Technical Service Bulletin: tsb102558

Revision, Clean and Inspect for Reuse Steps, Lubricating Oil Cooler and Lubricating Oil Thermostat Procedures

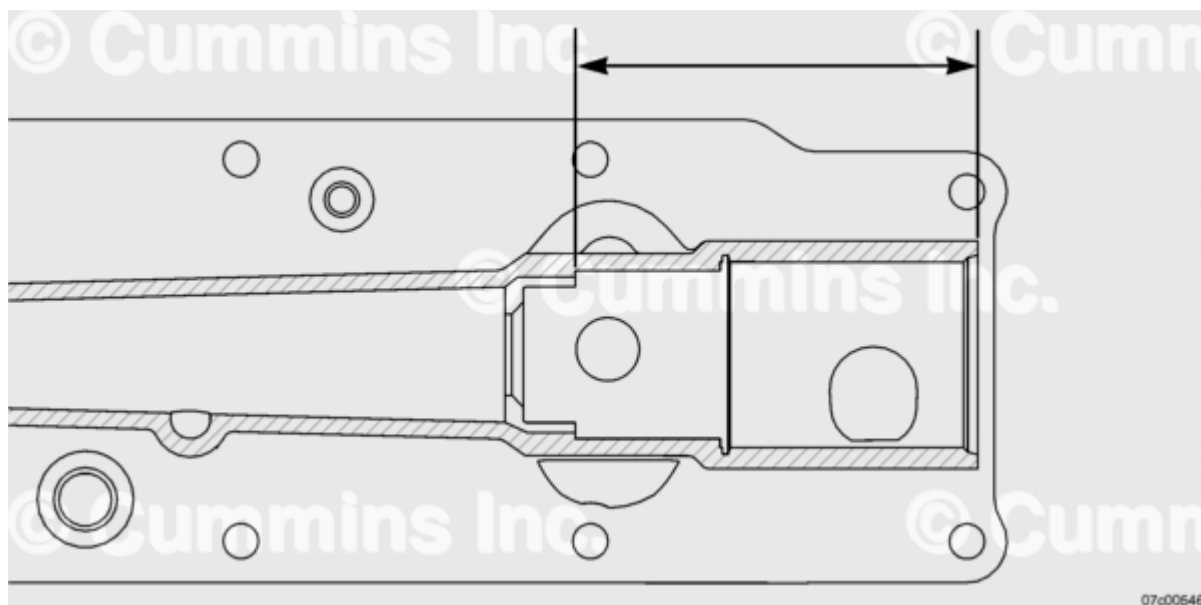
This Service/Parts Topic identifies how to inspect the oil thermostat seat depth in the oil cooler housing in Procedure 007-003 (Lubricating Oil Cooler) and adds a link in Procedure 007-039 (Lubricating Oil Thermostat) in the Signature, ISX, QSX15 Service Manual, Bulletin 3666239.

Shallow thermostat seat depth can lead to damaged oil thermostats and problems with oil pressure fluctuation. If the seat depth dimension is below the minimum specification, the oil cooler housing will need to be replaced.

Distance From Seat to Spot Face at End of Lubricating Oil Cooler Housing		
123.47 mm	Minimum Dimension	4.861 inch

Use this reference dimension for the following lubricating oil cooler housing part numbers: 4952496, 4952497, 4952507, and 4952508.
